[Docket No. FAA–2008–0490; Directorate Identifier 2008–SW–26–AD; Amendment 39–15509; AD 2008–10–03]

#### Airworthiness Directives; Bell Helicopter Textron Model 204B, 205A, 205A–1, 205B, 210, 212, 412, 412CF, and 412EP Helicopters

**ACTION:** Final rule; request for comments.

T/R Blade Assembly  
Figure 1

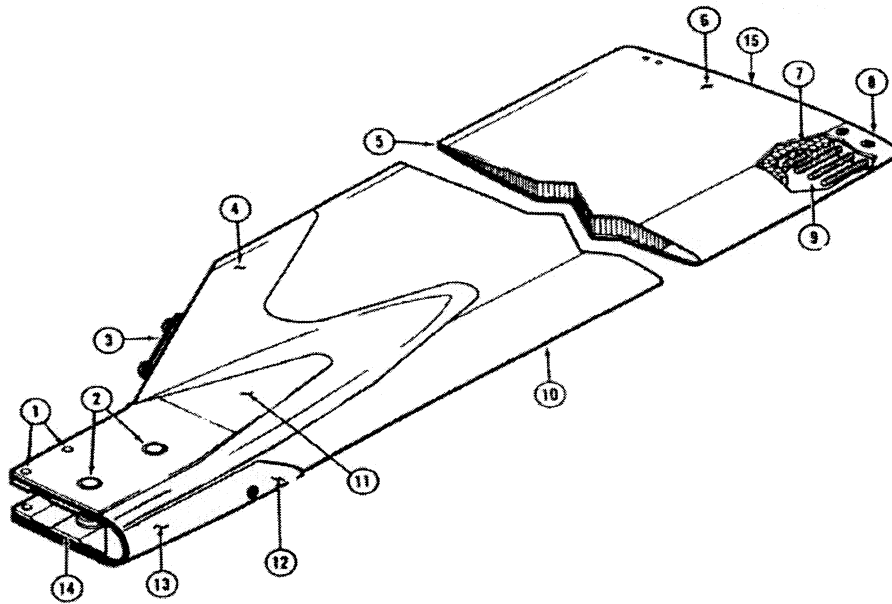
<p>Recommend changing areas called out for special attention to Stations 25.0 to 35.0 (both sides) for damage/corrosion and include inboard blade butt area surrounding balance weights/screws for cracks.</p>	<p>While the standard Model 204B helicopter may not use this particular T/R blade, the 212-010-750 T/R blade may be on a modified Model 204B helicopter that does use this blade. To assure that we have covered all affected blades, the applicability now encompasses all affected dash-numbered T/R blades.</p>
<p>There have not been eight reported failures, there have been three. All others are reported cracks in the blade skin, not “failures.” The term “failure” can be misleading.</p>	<p>Agree with this change and have revised this AD accordingly.</p>
<p>Bell objects to our statement in the NPRM that “The requirements of the proposed AD would be interim actions until either a more rigorous inspection is developed or a new blade that is more damage tolerant is designed.” Bell states “Although we are in concept discussions with DND, completion and certification of this blade is many months away and could be misleading to the commercial community.”</p>	<p>A crack in a blade makes that blade unable to safely perform its intended function. Thus, there are now 9 T/R blades that meet that criteria.</p>

(2) Using a 3-power or higher magnifying glass and a bright light, visually inspect the T/R blade skins, leading edge spar, doublers, grip plates, and trailing edge for a crack, corrosion (may be indicated by blistering, peeling, flaking, bubbling, or cracked paint) and any other damage (including a nick, scratch, or dent). See Figure 1 of this AD. Pay particular attention to both sides of the T/R blade in the area located 16 to 26 inches from the T/R blade tip (blade station 25 to 35—the T/R blade tip is located at blade station 51) and to the inboard blade butt area near the attachment of the external balance weights
